Omarunui Landfill Designation - further information request

Appendix A: Landscape report

LANDSCAPE ASSESSMENT OMARUNUI LANDFILL AREA B Proposed Landfill Site

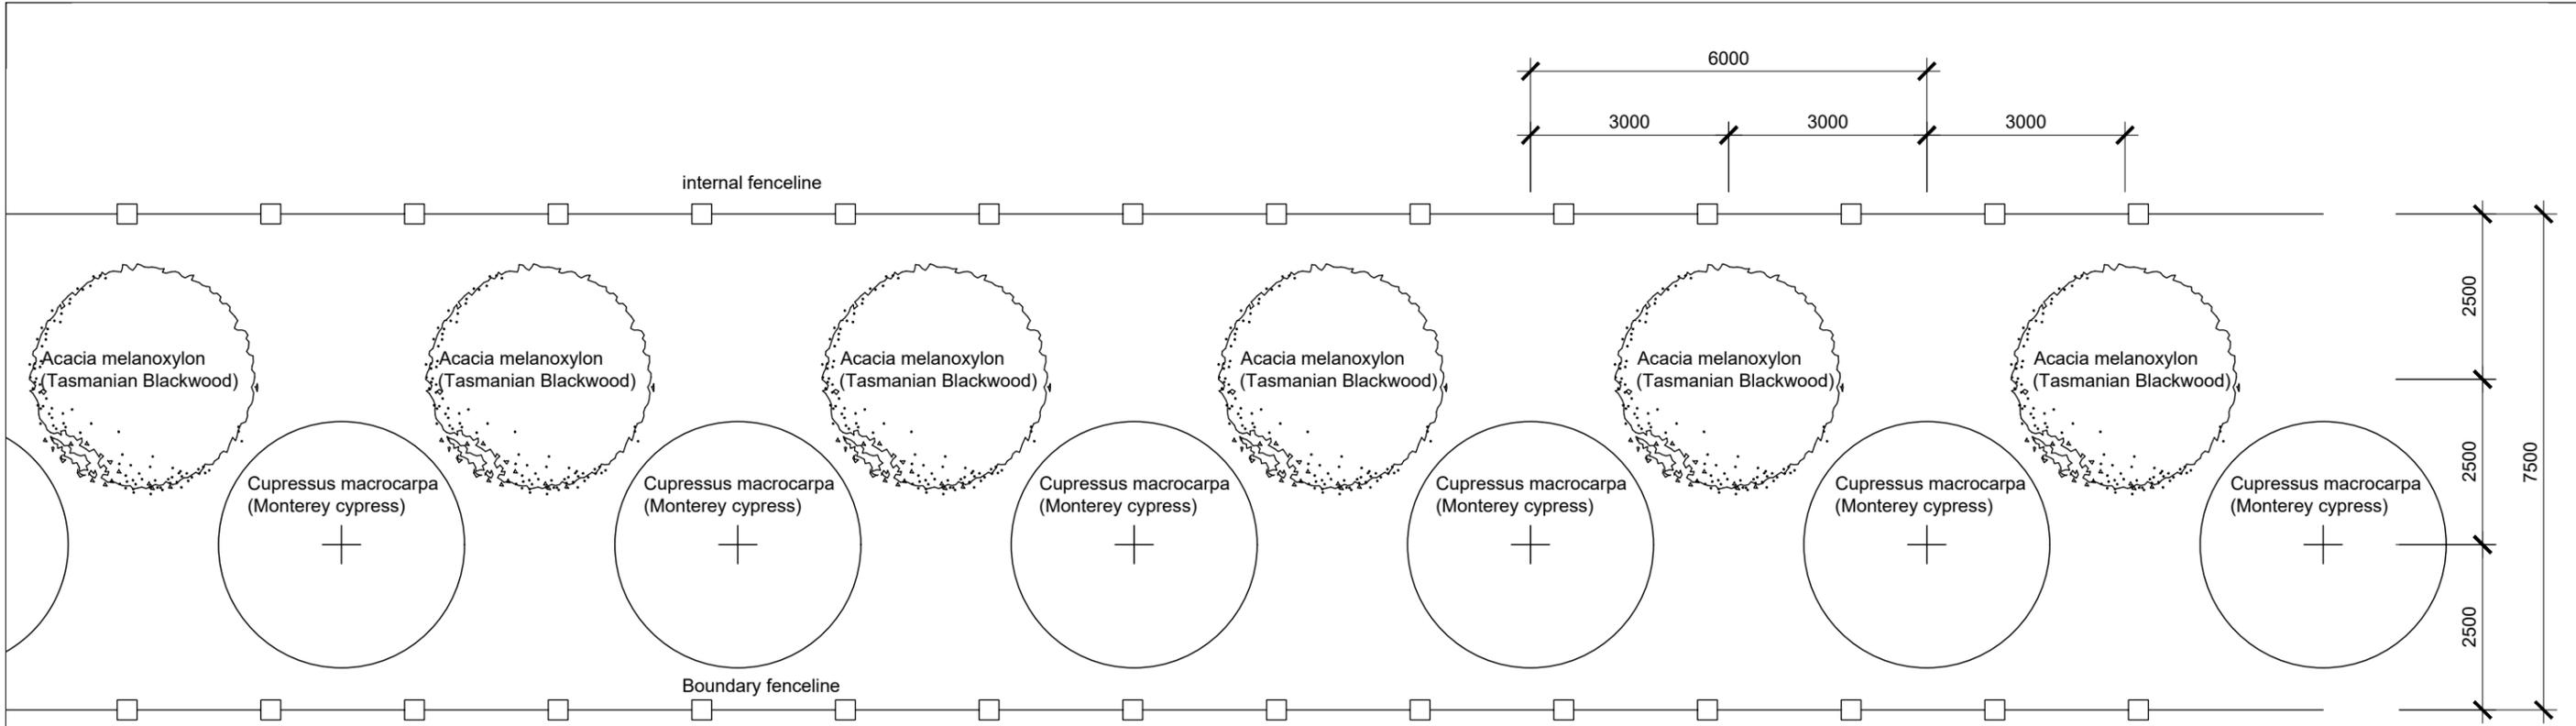
between the two ridges. The view of the landfill will be less dominant with the proposed planting. Refer Figure 8 : OL 4 Proposed Landscape Plan.

proposed Cupressus macrocarpa (1 row) and Acacia melanoxylon (1 row) 8m wide shelter belt planted on north ridges and in saddle (approx. 860m long)

proposed Cupressus macrocarpa (1 row) and Acacia melanoxylon (1 row) 8m wide shelter belt planted on east ridge (approx. 600m long)

Revision C : 03.03.2020
Proposed shelter belt plantings on north and east ridgelines
